<b>SERVICE LETTER NUMBER 139</b>			
<b>TITLE: MAIN LANDING GEAR (MLG) THREADED COUPLER</b>			
BY: S. ST. JACQUE	AIRCRAFT MAKE/MODEL(S):  N/A	FLOAT MODEL(S):  2100, 2350	NOTE(S): MANDATORY COMPLIANCE <b>S/L P/N 1005856</b> <b>ECO 23053</b>
APP: D.GARRETT			
DATE: 03/15/13			
REV: A

**FAA APPROVAL HAS BEEN OBTAINED FOR TECHNICAL DATA IN THIS PUBLICATION THAT AFFECTS STC OR TSO DESIGN COMPLIANCE**

DETAIL A

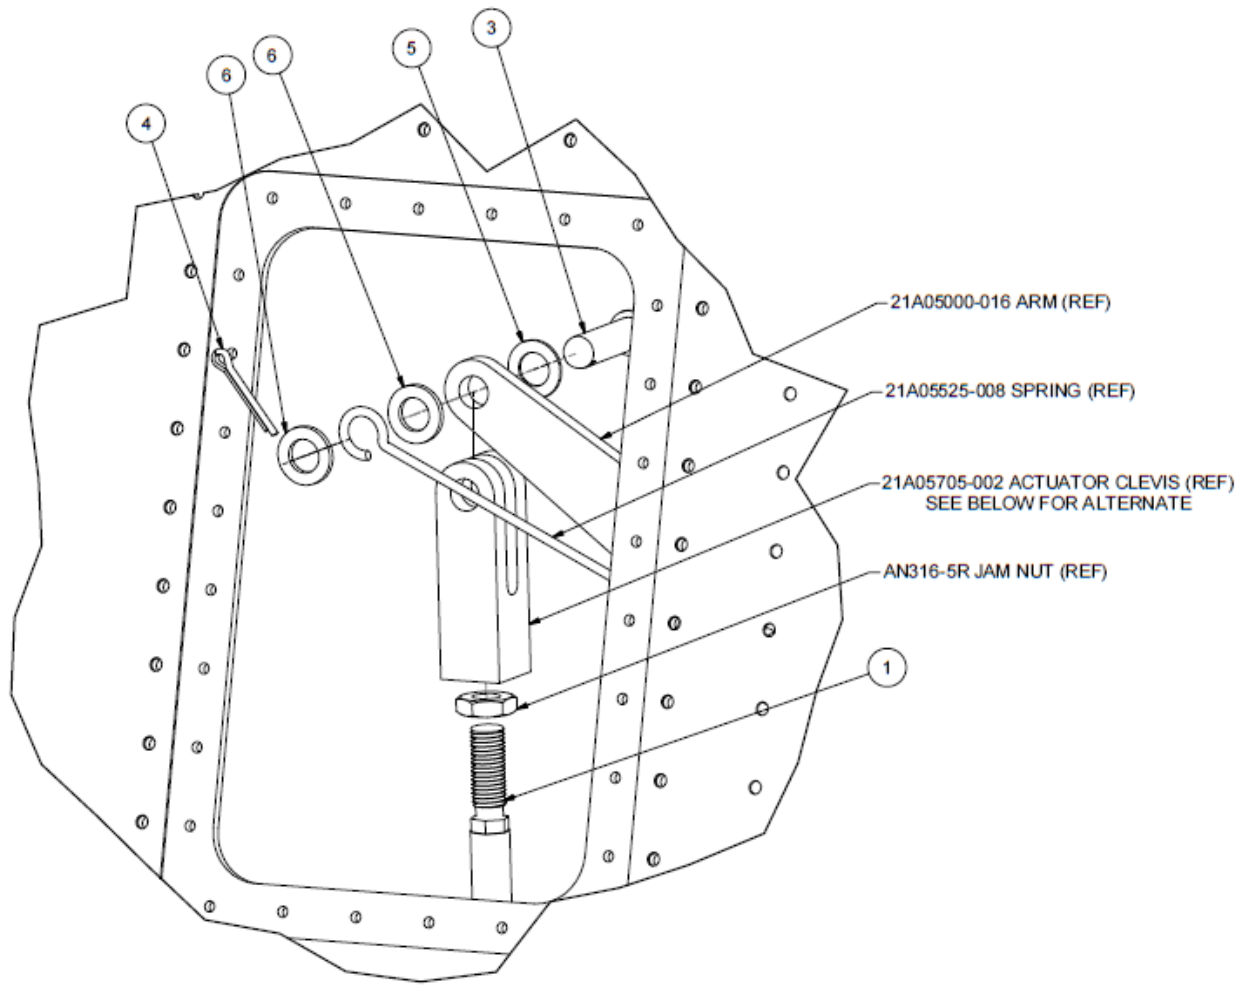
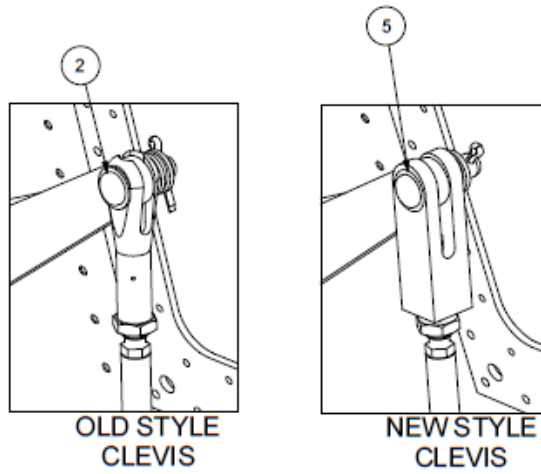
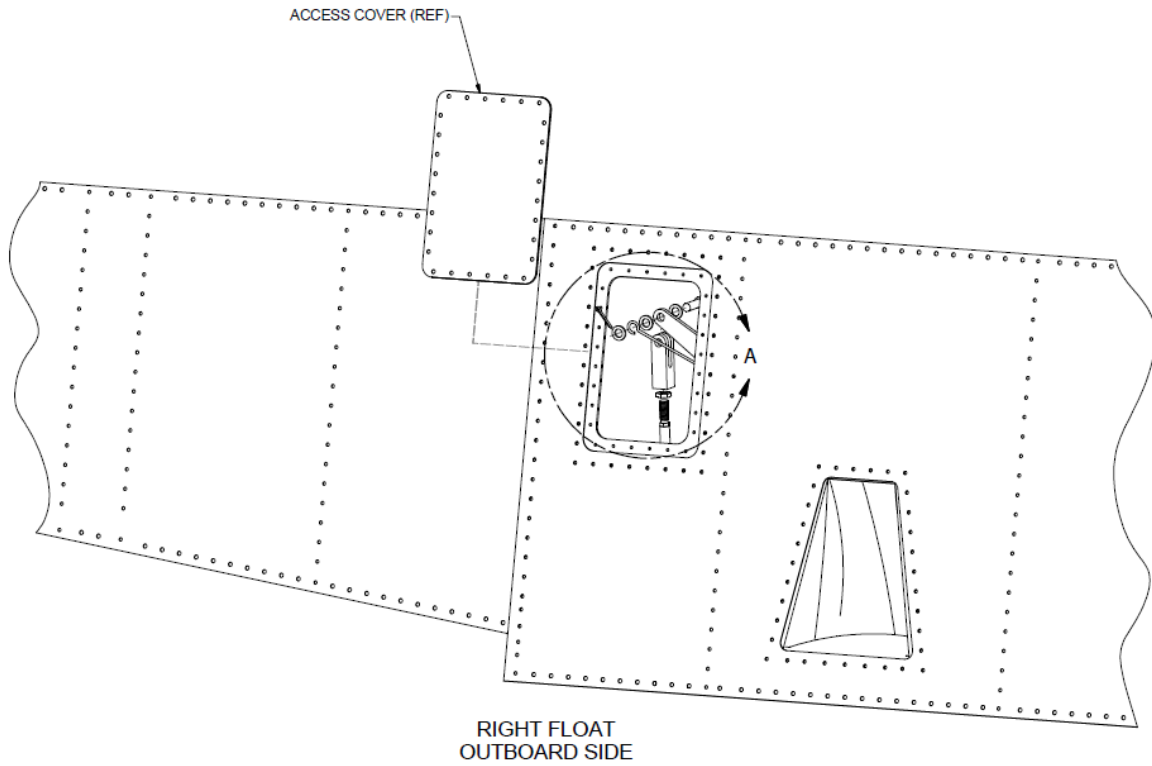
Corrosion may occur on the threaded connection between the Main Gear Hydraulic  
Retract Actuator and connecting clevis. This service letter and associated kit replaces  
the threaded connection with a stainless steel version of the same part. It also replaces  
the connection hardware with a Clevis Pin instead of a bolted connection.

1. Perform the following service procedures after first securing airplane.
2. Jack up the Main Gear until the tire is not in contact with the ground. (refer to Float Service Manual Section 4.0)
3. Remove access cover as shown.
4. Remove Hydraulic Actuator Clevis and connection hardware. Discard hardware.
5. Remove and replace ASH-000WA Threaded Coupler with ASH-316WA.
6. Reuse jam nut on ASH-316WA.
7. Reattach Actuator Clevis to ASH-316WA.
8. Adjust rigging per 2100/2350 Wipaire Float Service Manual Section 5.2. [www.wipaire.com](http://www.wipaire.com)
9. Coat the attach hardware with grease and install as shown.
10. Reinstall the access cover.
11. Lower float on to Main Gear and repeat the service procedure on the opposite float.

TABLE 1			
ITEM	QTY	PART NUMBER	DESCRIPTION
1	1	ASH-316WA	STAINLESS STEEL THREADED COUPLER
2	1	MS20392-4C25	CLEVIS PIN (OLD STYLE CLEVIS)
3	1	MS20392-4C29	CLEVIS PIN (NEW STYLE CLEVIS)
4	2	MS24665-283	COTTER PIN
5	1	NAS1149F0532P	WASHER
6	2	NAS1149F0563P	WASHER
